Re: Reinke Manufacturing Company, Inc. Part 573 Report Submission

## **PART 573 Defect and Noncompliance Report**

This report serves as Reinke Manufacturing Company, Inc.'s ("Reinke") notification to the U.S. Department of Transportation, National Highway Traffic Safety Administration that a defect related to motor vehicle safety exists in certain intermodal chassis. Reinke decided that this defect existed in these vehicles on April 24, 2012.

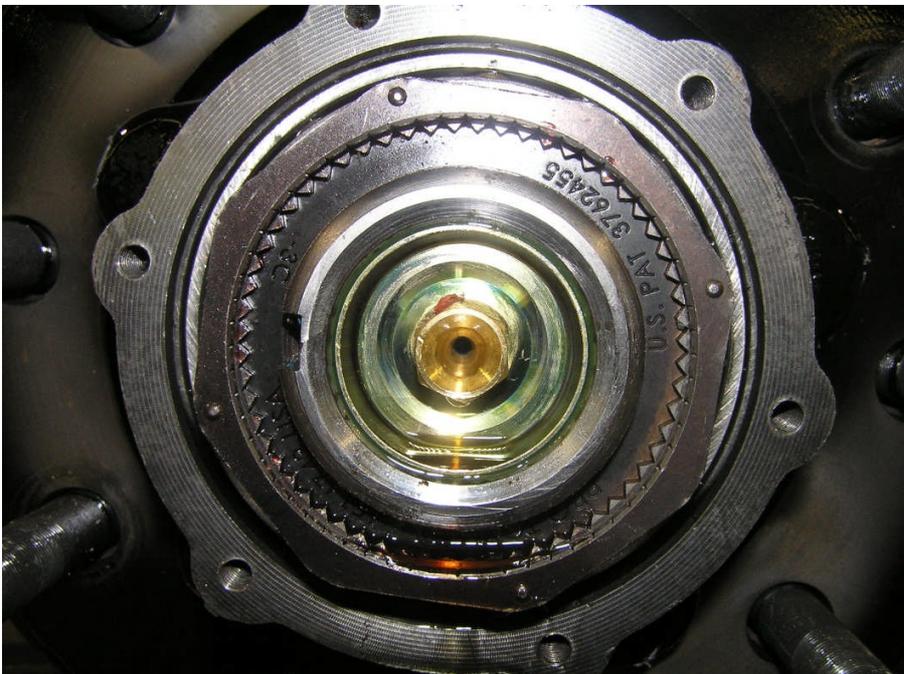
There are two defects to be addressed in this recall. The first involves the lack of or improper installation by Power Products of an orange-colored locking ring that secures the spindle nut on the Power Products axle. See additional photos below.

**Locking ring installed correctly.**

**Locking ring installed incorrectly.**

**Missing locking ring.**

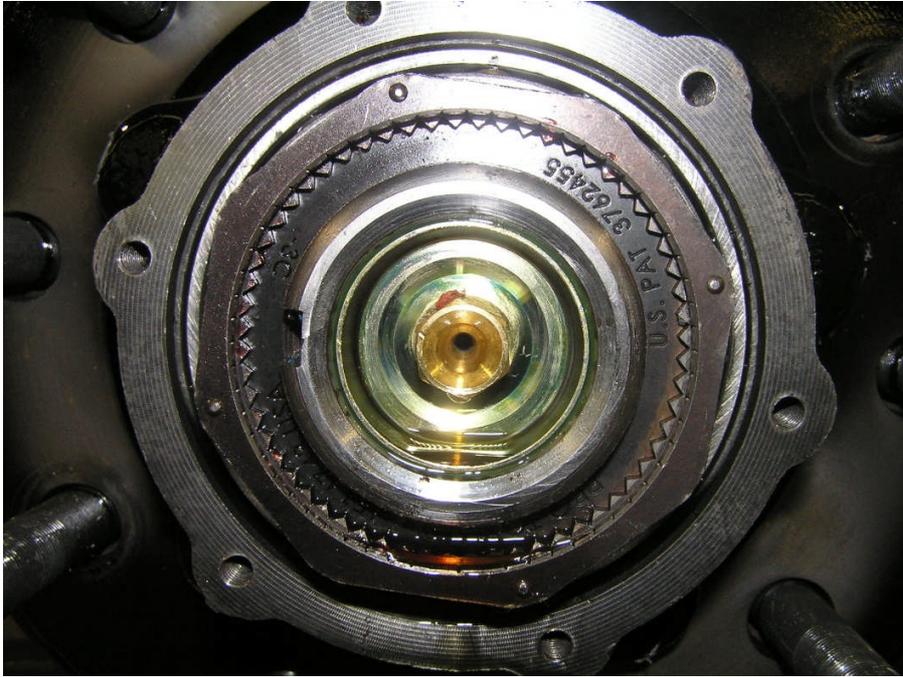
Clearly describe the distinguishing characteristics of the remedy component/assembly versus the recalled component/assembly.

Locking ring:  
Remedied locking ring.

Recalled locking ring.

**Recalled locking ring.**
